Town of Simsbury

ADDENDUM #1
August 2, 2017

SANITARY SEWER IMPROVEMENTS
MAPLE COURT AND OLD MILL COURT

SHEET
1

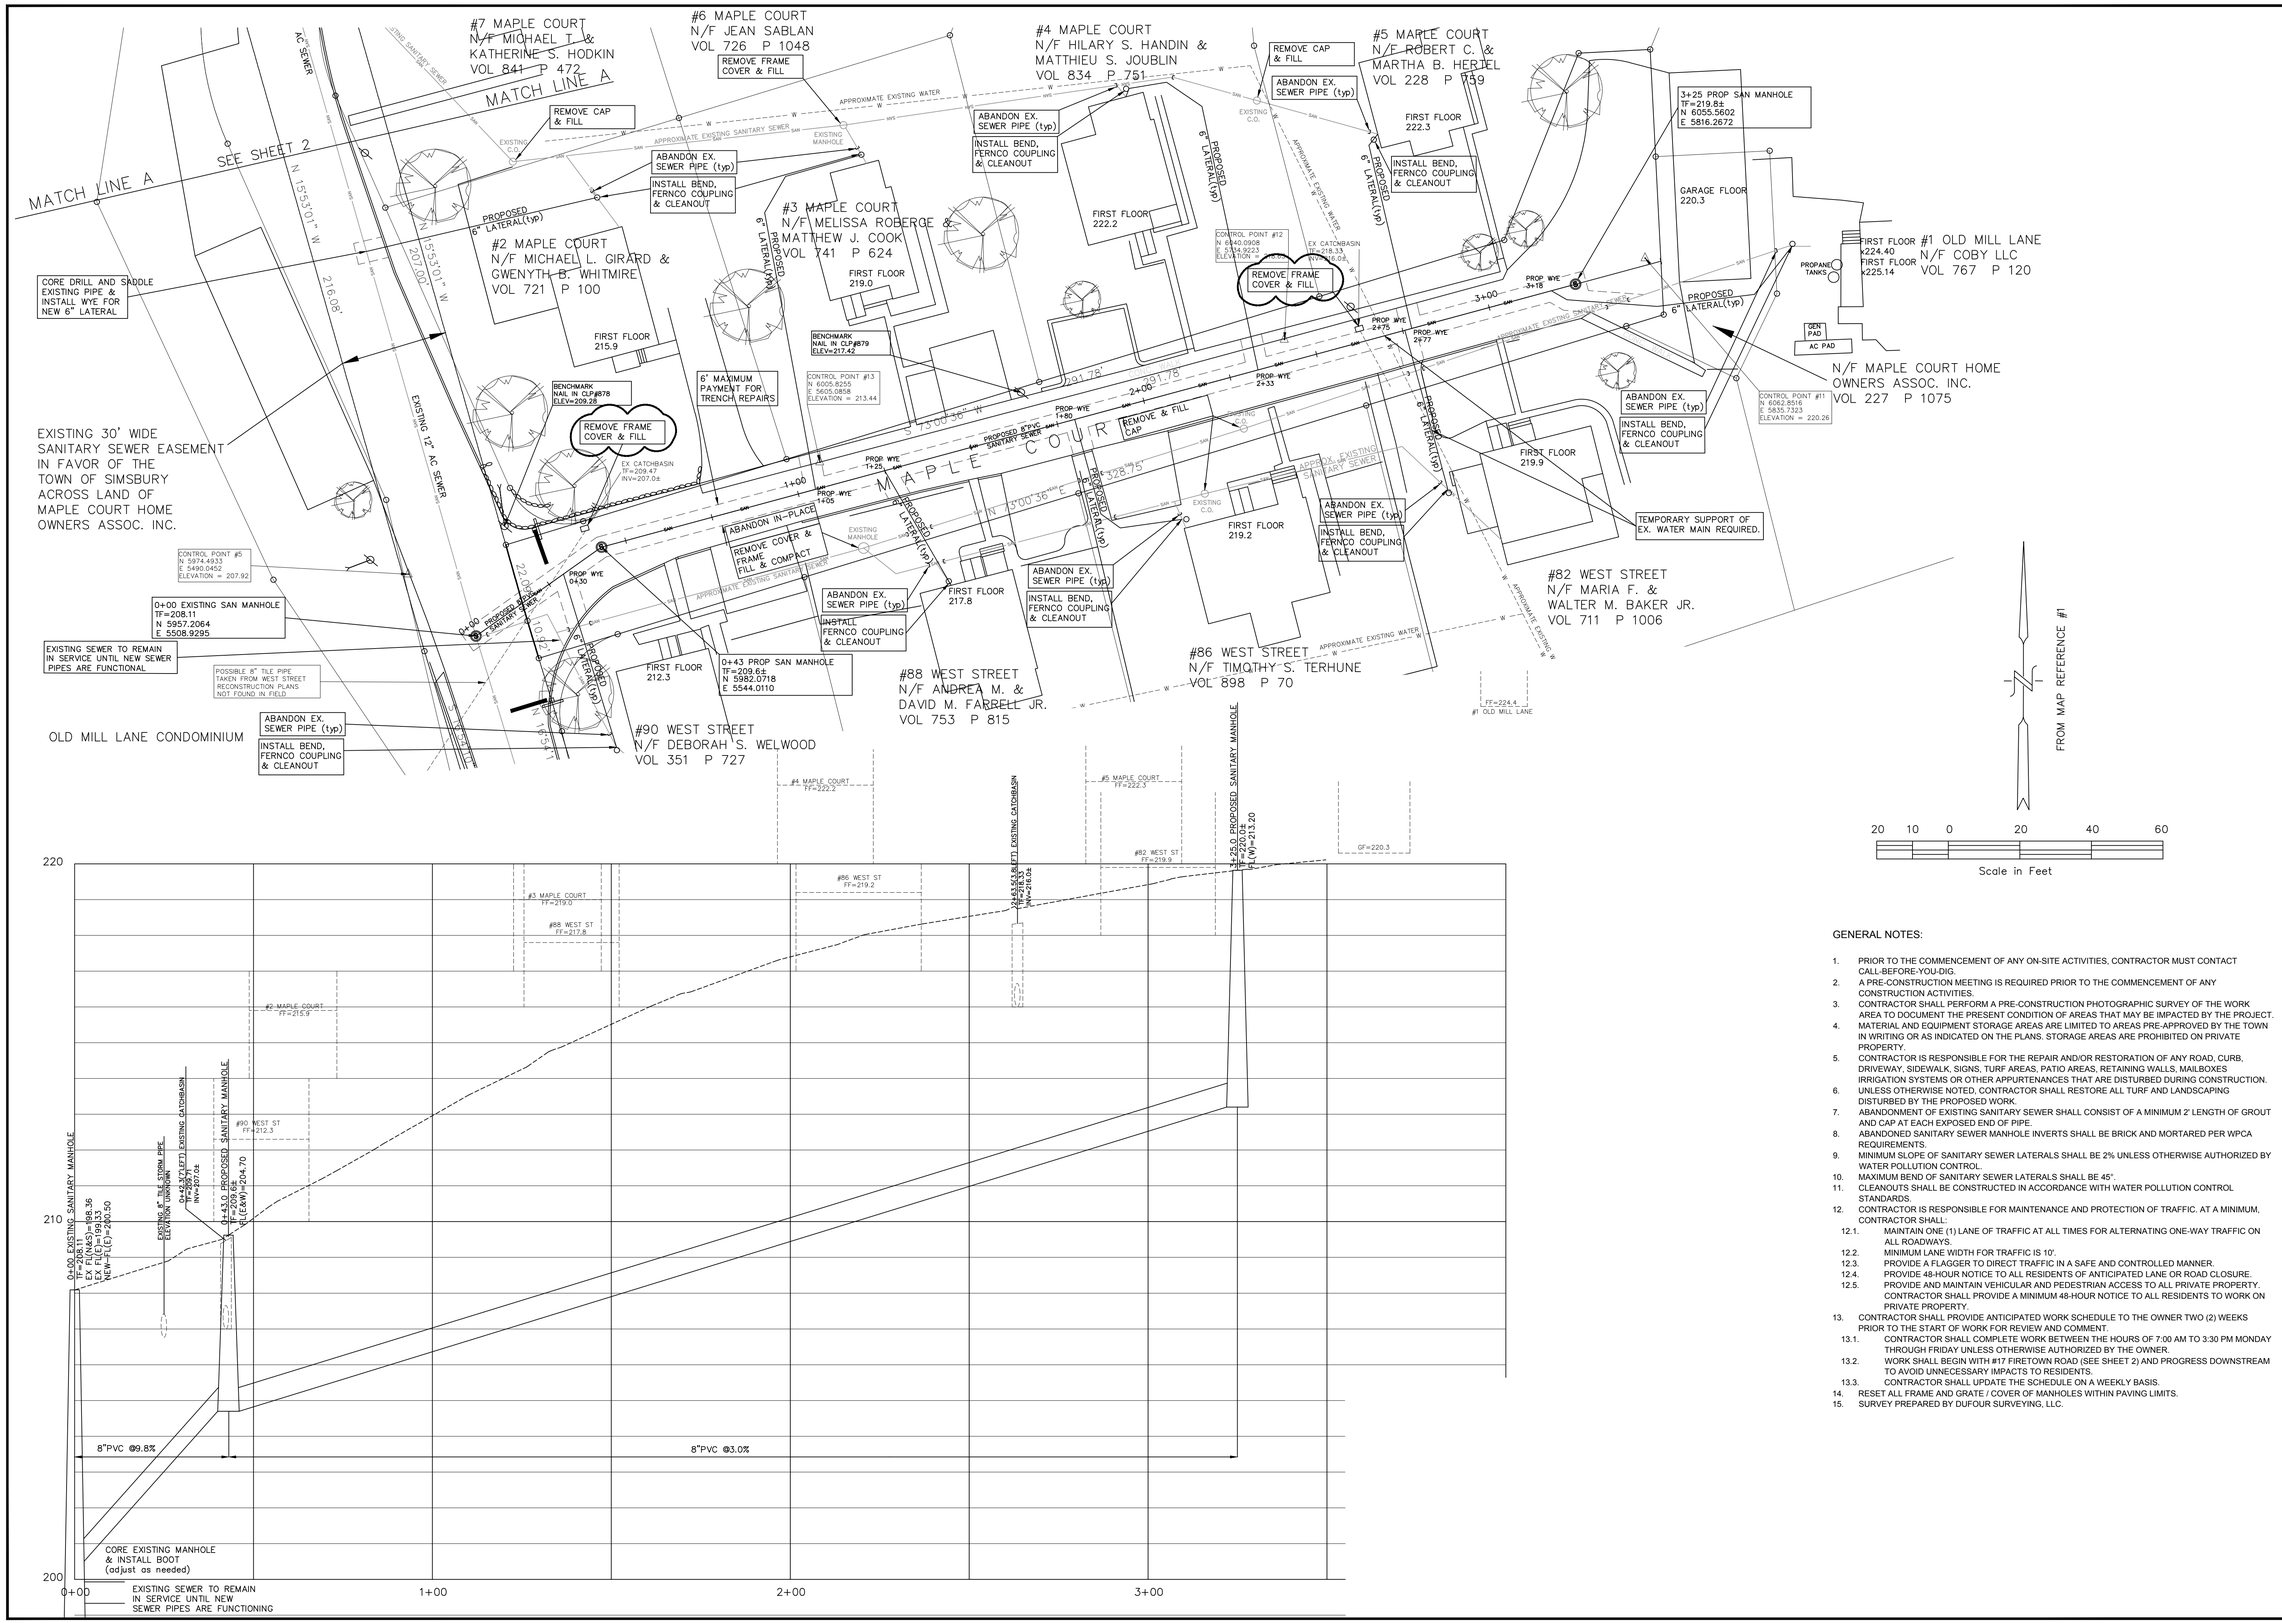
1. Sheet 1

a. CHANGE: “Replace Existing Conc. CB, Reset Ex. Frame and Grate” to “Remove Frame, Cover and Fill.”
    b. CHANGE: “Reset Ex. Frame and Grate” to “Remove Frame, Cover and Fill.”

PROPOSED SANITARY SEWER LATERAL
#17 FIRETOWN ROAD

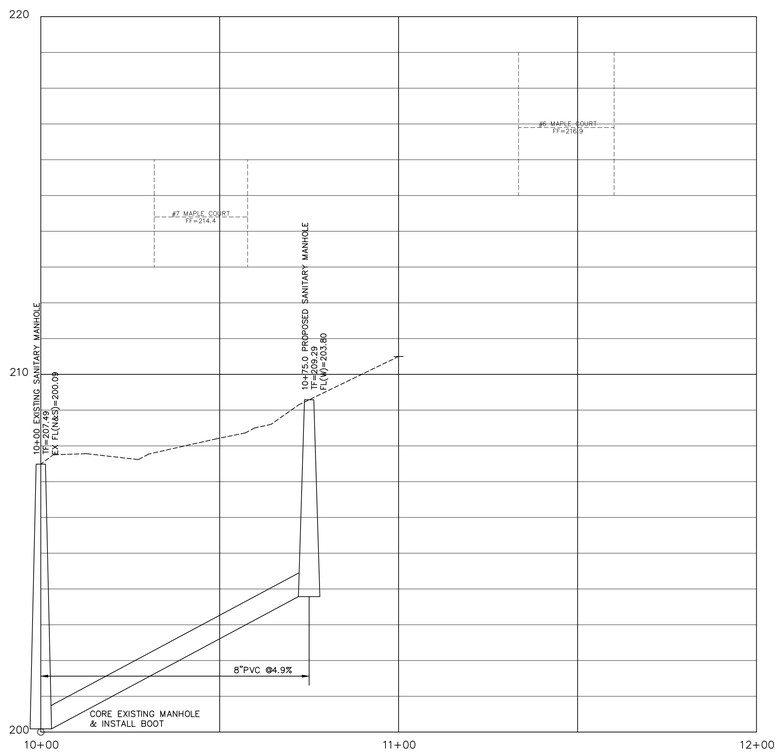
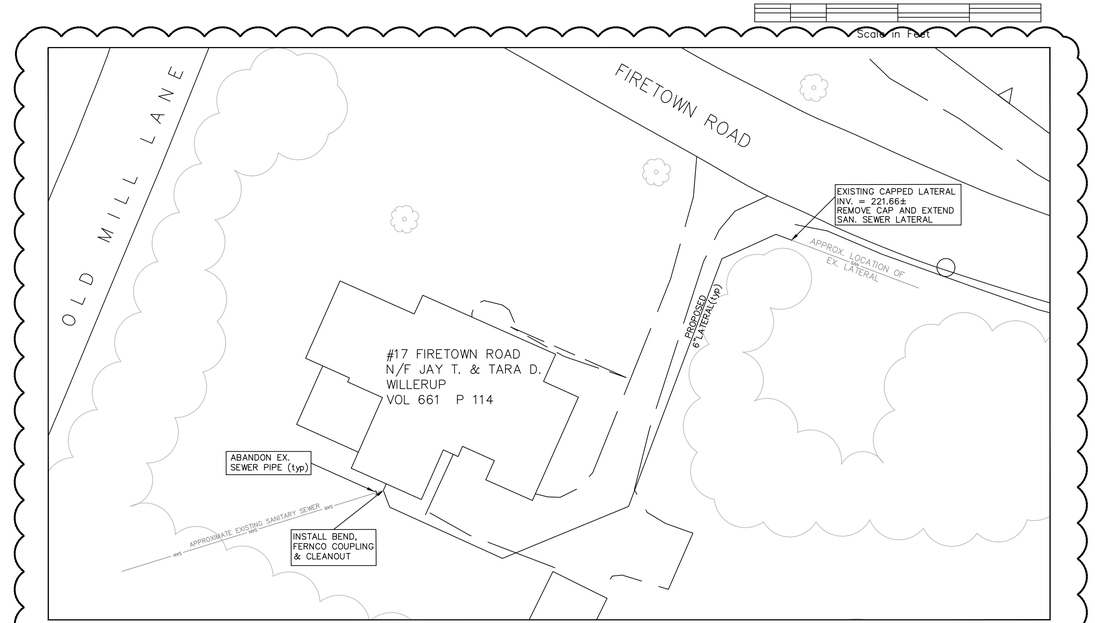
2. Sheet 2

a. Proposed Sanitary Sewer Lateral, #17 Firetown Road
        i. REVISE: Location of existing capped lateral and proposed lateral route.

MAPLE COURT SECTION A-A
N.T.S.

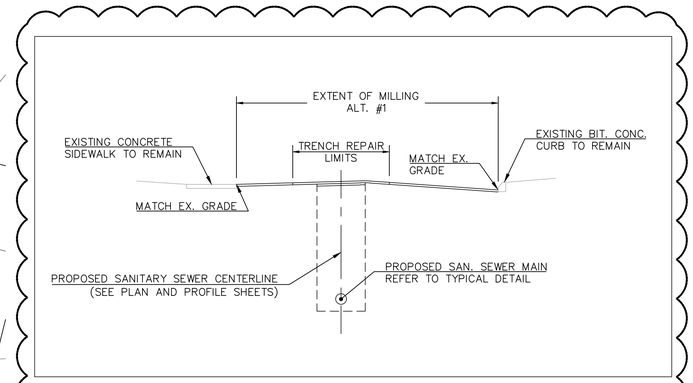
3. Sheet 4

a. Maple Court Section A-A
        i. DELETE: “Existing Gutter Profile to Remain”
        ii. DELETE: “Reconstruct Ex. Bit Concrete Swale – Alt. #1
        iii. REVISE: “Extent of Milling, Alt. #1” to include full width from existing concrete sidewalk to existing curb.
